ADDENBROOKE PTY LTD
 Project
 ROSE BAY AND POINT PIPER MARINA REDEVELOPMENT

Date 12 November 2007
File No. 871.G
To Peter Kauter – Executive Planner
CC
From David Sheils - Manager Public Open Space
Subject ROSE BAY MARINA DA 766/2006/1

REFERRAL RESPONSE – TECH. SERVICES

REFERRAL RESPONSE – HERITAGE

FIGURE 3 Density comparison of swing moorings and fixed berths

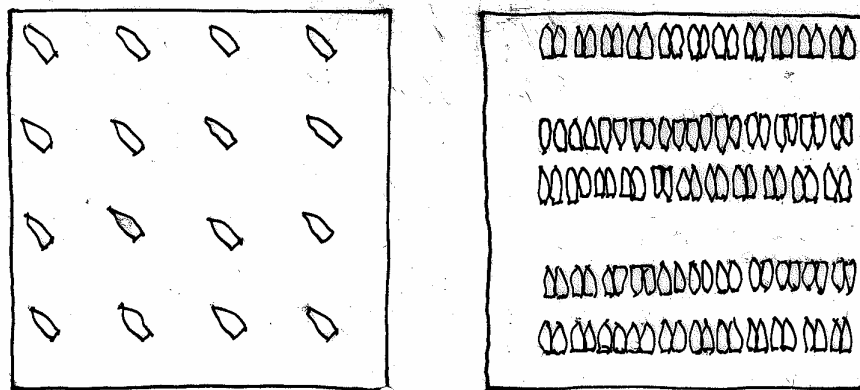
The marina proposal reduces the number of swing moorings and increases the amount of vessels at berths. The density of vessels on swing moorings is controlled by the geometry of the boat's swing. This natural control on density means that swing moorings as a visual component in a bay are permeable and able to be seen through and beyond. The provision of fixed berths allows more large vessels to be moored in the bay. A density comparison of swing moorings and fixed berths is instructive. Sixteen boats 10m long can be accommodated on swing moorings in a hectare of water. One hundred and ten vessels 10m long can be accommodated in a hectare of fixed berths. Fixed berths are approximately 6.75 times denser than swing moorings. See **FIGURE 3**

FIGURE 5 Showing existing and proposed view cones from Rose Bay Park Beach

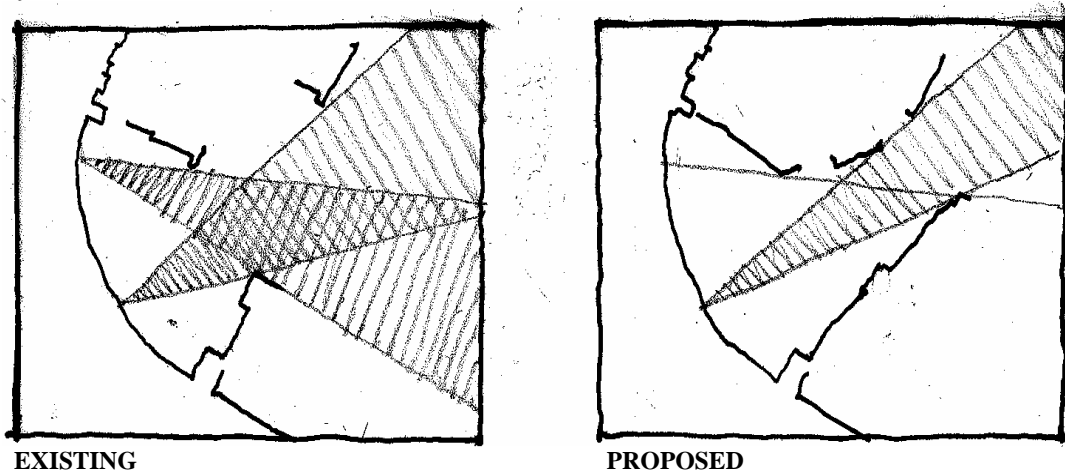
While the corridor will be free of permanent moorings, a number of pens on the Point Piper marina will be accessed from the corridor. Vessels will also need to navigate the corridor to access casual berths and refueling facilities. The proposed gap between the marinas on the east and west of this cleared area will be reduced from the 137m to 96m. This gap is illustrated in **FIGURE 5**.

The view cone from the beach will be considerably reduced from all parts of the beach by the extension of the Marina arms and the vessels moored there. The northern end of the beach will have views to the open water of Rose Bay completely blocked by vessels moored at the extended fixed berths. See **FIGURE 5**
